# MAINTENANCE BULLETIN

NO. 159  
AUGUST 1998

**SUBJECT: MAINTENANCE ADVISORY MESSAGE (MAM), TACOM-WRN  
CONTROL NO. MAM-98-006, FOR ALL M998 AND M998A1 SERIES HIGH  
MOBILITY MULTIPURPOSE WHEELED VEHICLE (HMMWV) EQUIPPED WITH  
100AMP ALTERNATOR**

**SUBJECT:** Rerouting Alternator Positive Cable

Figure 12

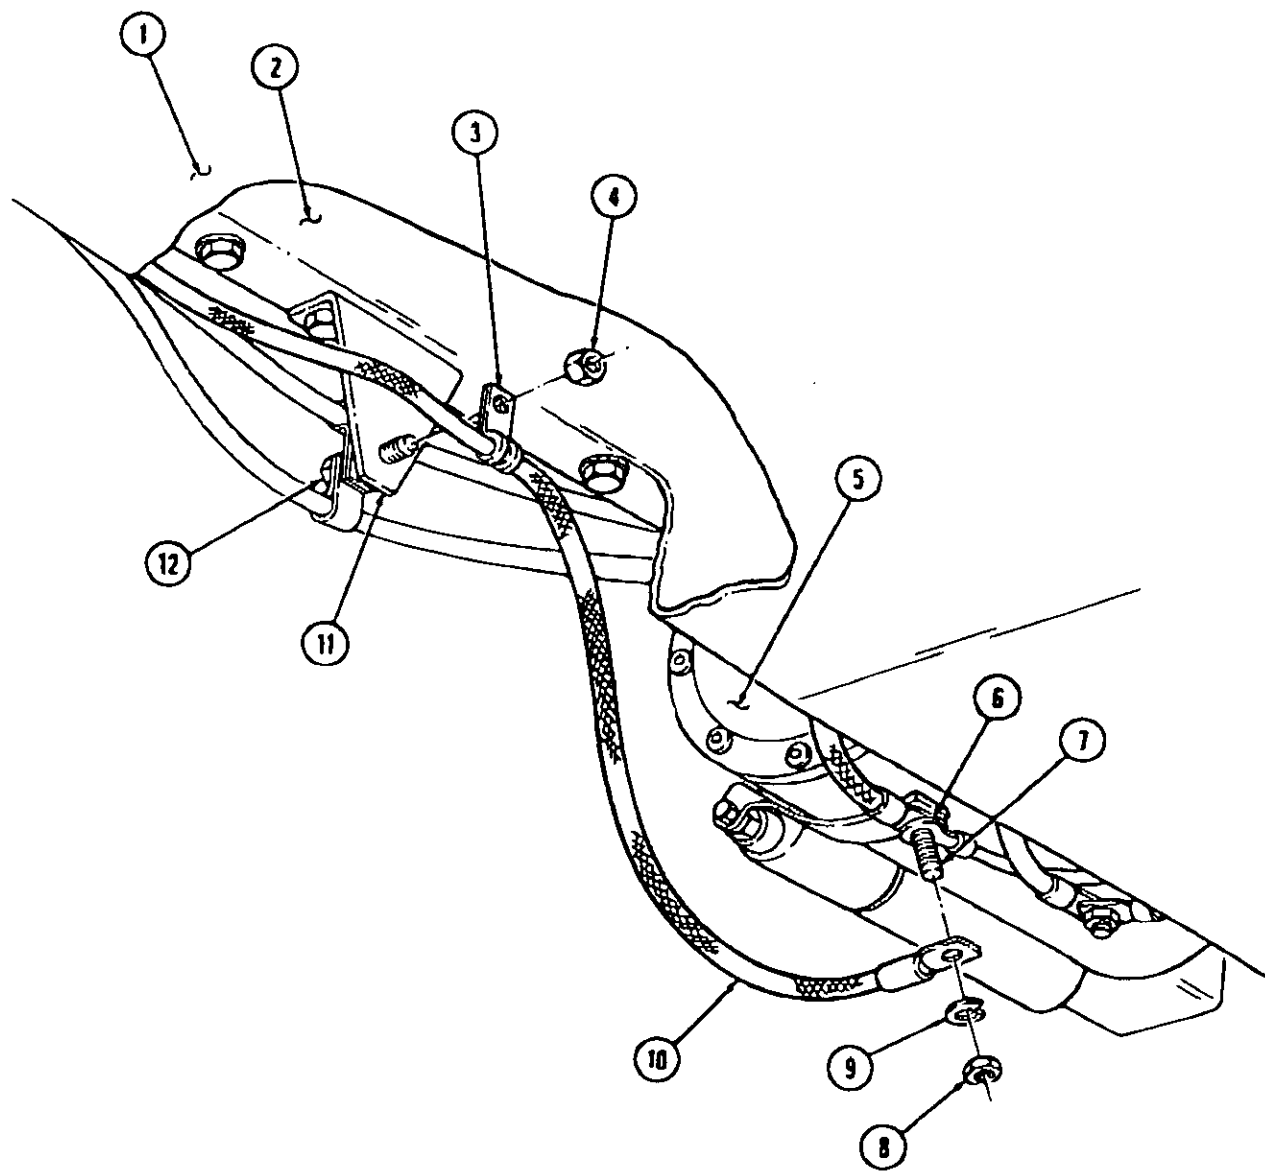
8. Route positive cable lead 6D (10) along right side of engine (2) and body (1) toward starter (5) as shown in figure 12.
9. Remove sealant from starter positive terminal (7) as shown in figure 12.

10. Remove nut (8) and lockwasher (9) from starter positive terminal (7) as shown in figure 12. Discard lockwasher (9).
11. Install positive cable lead 6D (10) on starter positive terminal (7) with NSN 5310-01-216-7390 lockwasher (9) and nut (8) as shown in figure 12. Tighten nut (8) to 25-30 lb-ft (34-41 N·m).

12. Apply NSN 8030-01-328-0574 adhesive sealant to positive terminal (7) and wire leads (6) and (10) as shown in figure 12.
13. Remove nut (4) from screw (12) on starter cable support bracket (11) as shown in figure 12. Discard nut (4).

14. Install NSN 5340-00-809-1494 clamp (3) on positive cable 6D (10) and secure to starter cable support bracket (11) with clamp (3), screw (12), and NSN 5310-01-152-0598 locknut (4) as shown in figure 12.
